Environmental Impact Report

# Montgomery - Washington Building

Final  
81.104E

Publication Date: November 13, 1981

● FIGURE 8A: Roof Floor Plan

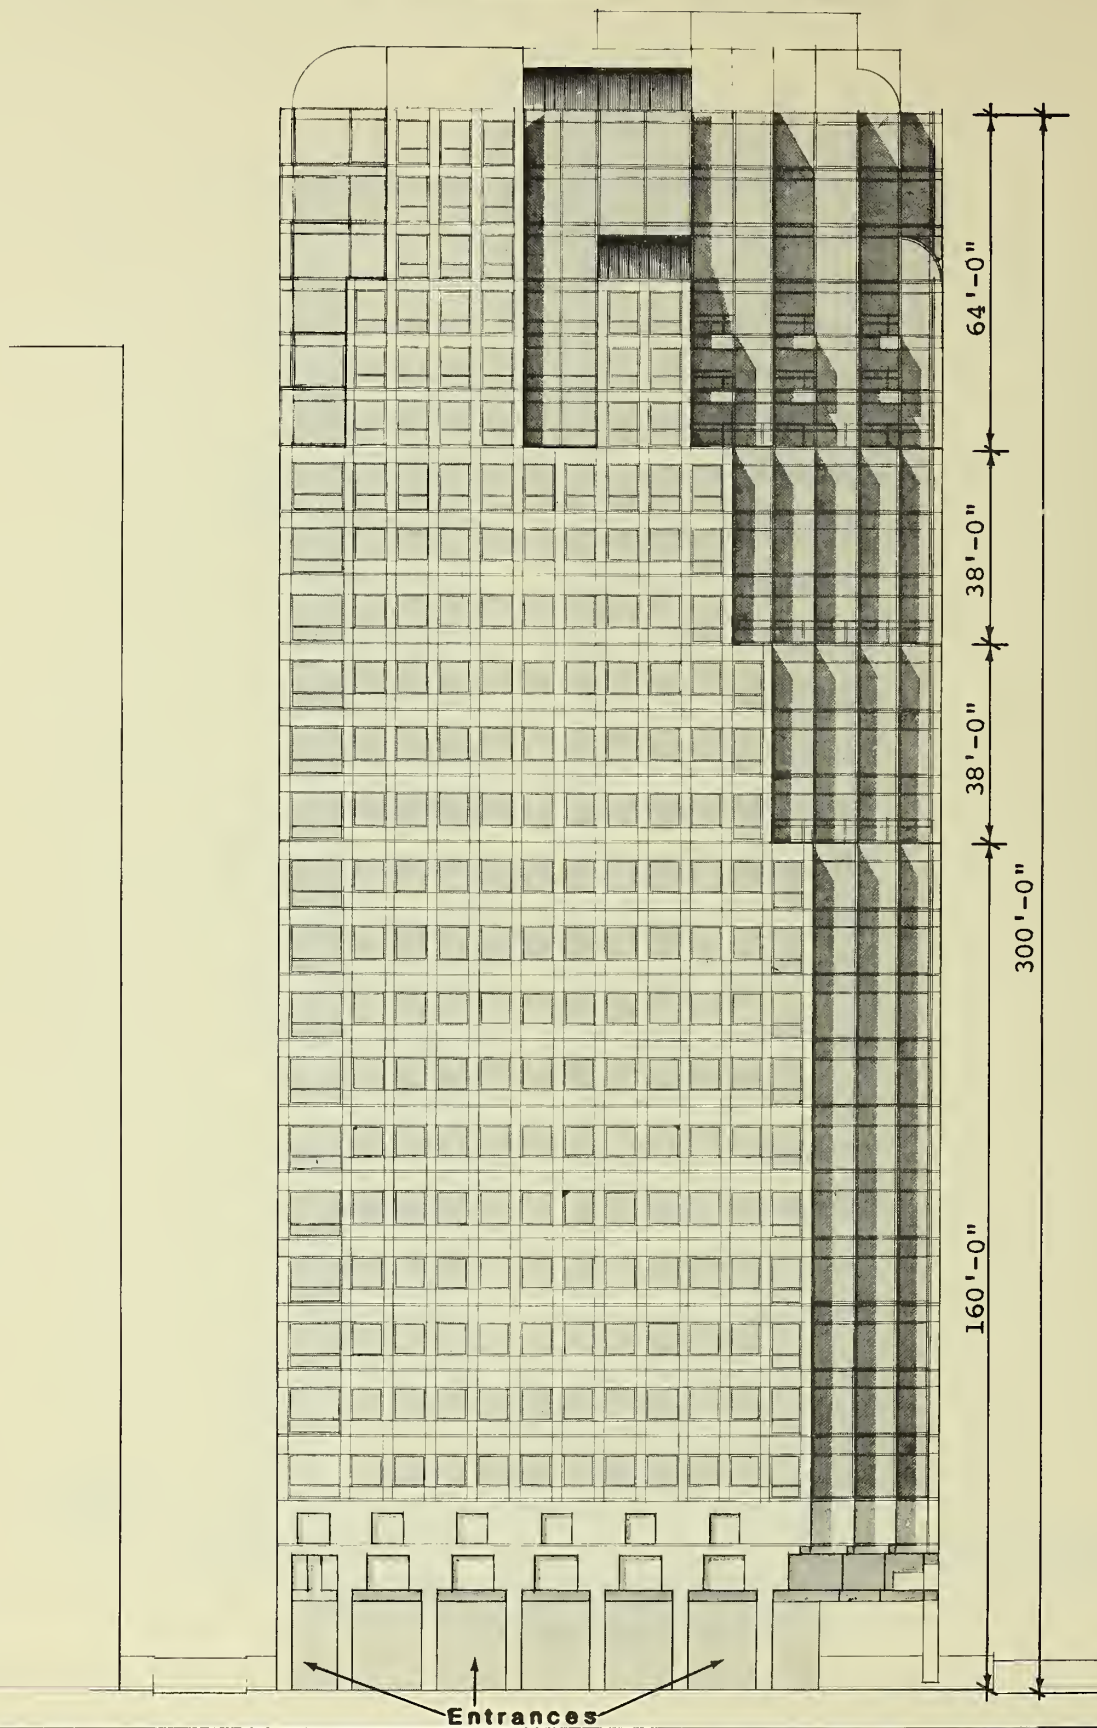
"Page 25 [paragraph one], the rooftop observation deck doesn't seem to have public access....If it does not, how can it be included as a bonus?" (Commissioner Bierman)

The rooftop common open space, described in the next to the last sentence on p. 14 of the DEIR, refers to the public observation deck. The observation deck, containing approximately 750 sq. ft. of space and accommodating about 50 persons, would be located at the northeast corner of the roof as shown in Figure 8A, Roof Floor Plan, p. 145. (Figure 8A is to be added following Figure 8 on p. 20 of the DEIR.). At the time the DEIR was published, it was proposed that, in addition to the observation deck, about 10,000 sq. ft. of common open space would be provided on the rooftop for building residents. This common open space on the rooftop has been eliminated as a result of refinement of the building design; the observation deck would be the only open space provided on the roof (See also the Response on p. 156, regarding open space).

The public would reach the observation deck via a freight elevator from the ground floor to the 24th story, the top residential floor. From this level, a stairway, and possibly a hydraulic lift, would allow access to the rooftop observation deck. Access to the observation deck by the public would be monitored by a security guard at the ground floor; the security guard would control operation of the freight elevator. According to the project sponsor, the observation deck would be open to the public during normal business hours.

The observation deck is shown in a new Figure 8A (p. 145 of this document), to be incorporated into the DEIR following Figure 8, p. 20. Ground-floor bonus features, including multiple building entrances, sidewalk widening and shortened walking distances are shown in a new Figure 11A (p. 147 of this document), to be added following Figure 11 on p. 24 of the DEIR. The remaining bonus feature, parking access, cannot be illustrated in a diagram or floor plan. As defined in Section 126(3) of the City Planning Code, parking access "shall be from the subject building directly to an automobile parking structure located elsewhere than in the areas of concentrated development of the C-3-0 and C-3-R districts....The access shall be open during all business hours for use by occupants or visitors to the subject building and marked for their use..."

● FIGURE 29A: Alternative Three A-  
Stepped Height Alternative

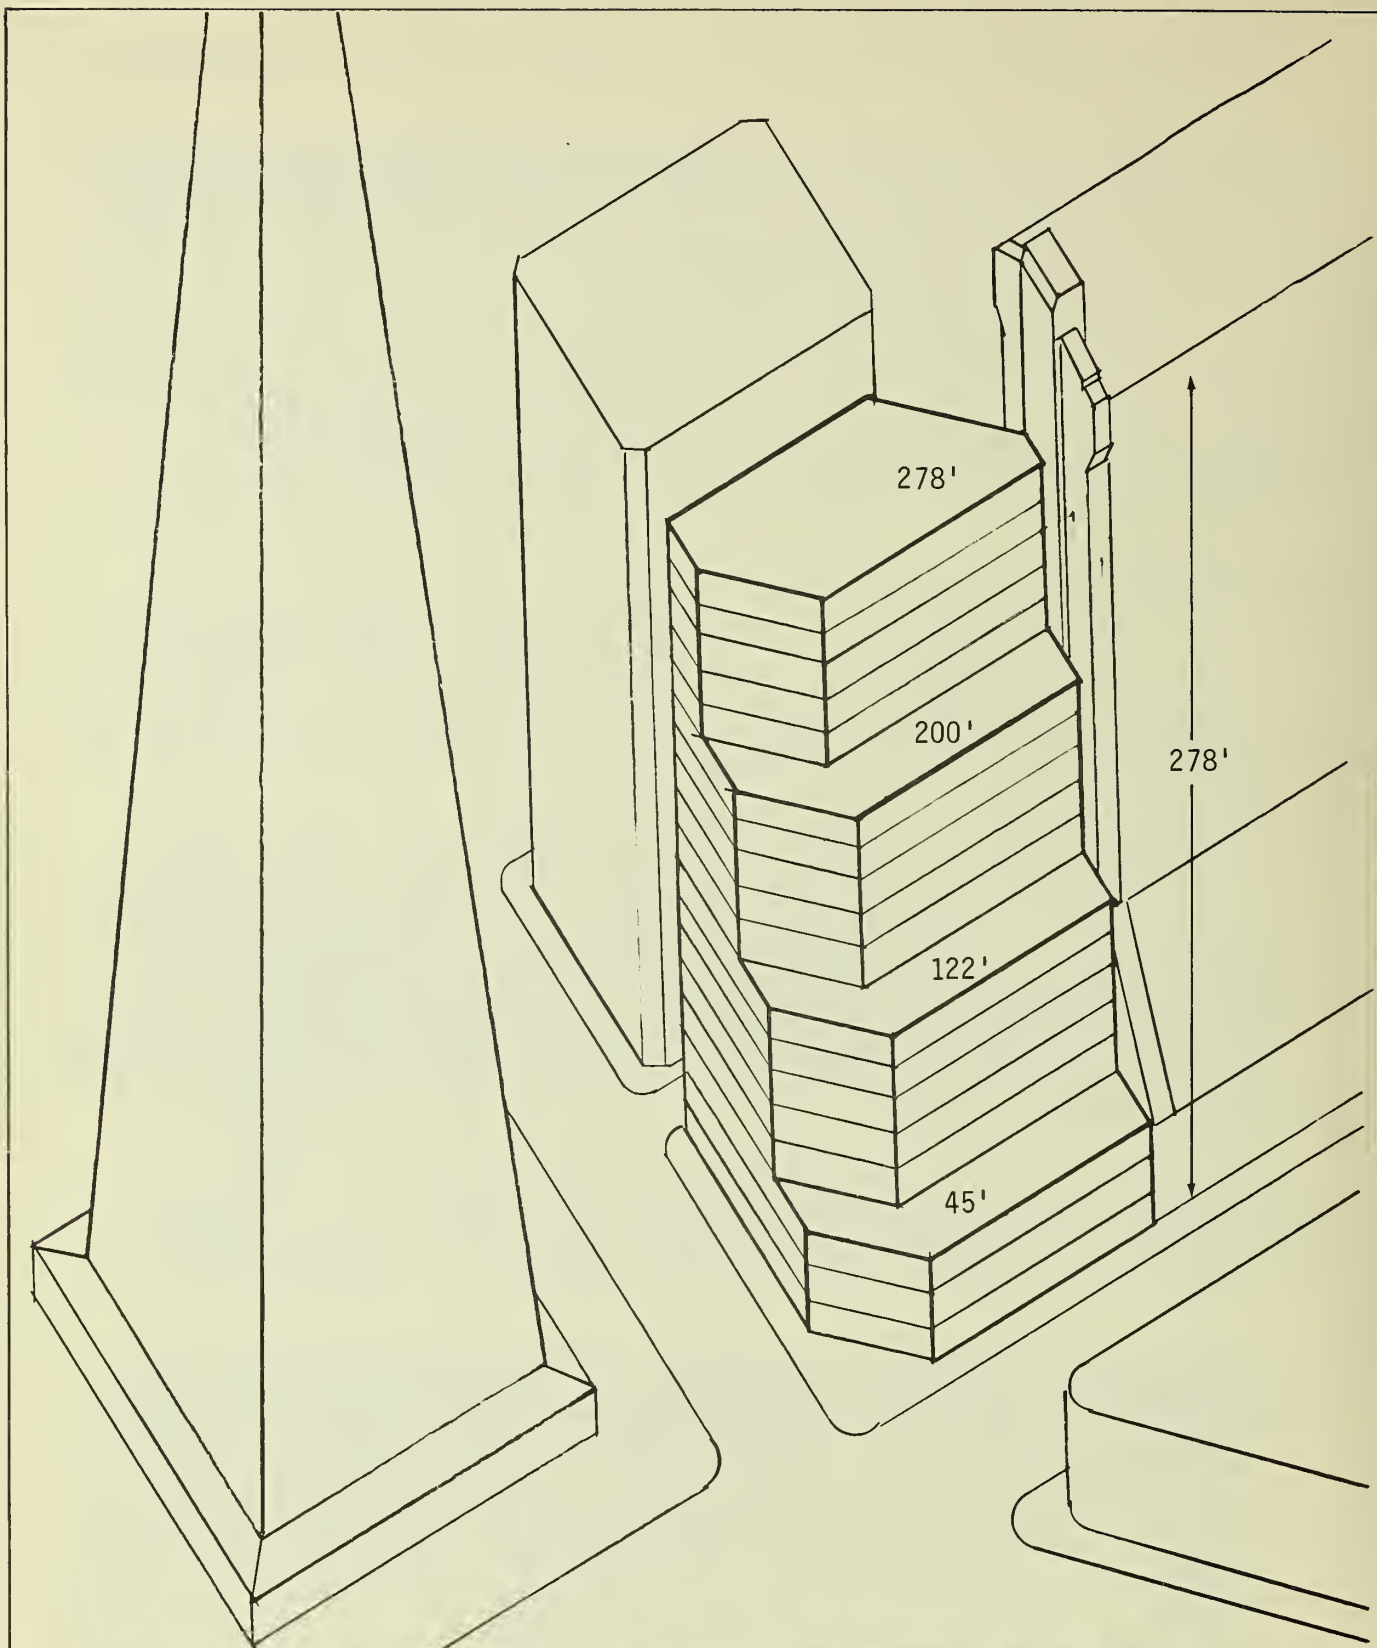
"This structure should be viewed as one which steps down from that adjacent building, not stepped up....I would like to urge that a complete environmental review be done on a project which would meet the requirements of Jackson Square, in protecting Jackson Square, and that be presented as probably a new Draft EIR. Because I think this is so in conflict."  
(Sue Smith)

For a discussion of project shadow impacts on the Jackson Square Historic District, see Response on p. 157. The following alternative has been developed in response to identified shadow and urban design impacts of the proposed project. This alternative is added to the DEIR after the second full paragraph on p. 131 of the DEIR.

This alternative would consist of an office building reaching a maximum height of 278 ft. (see Figure 29A). The building would step down toward Washington St. in a series of three setbacks from the height of the adjacent 280-foot-tall 601 Montgomery St. building. Alternative Three A would contain approximately 243,600 sq. ft. of commercial space, representing an FAR of about 14:1, including ground-floor retail and lobby space and 16 floors of office use. There would be no residential development on the site.
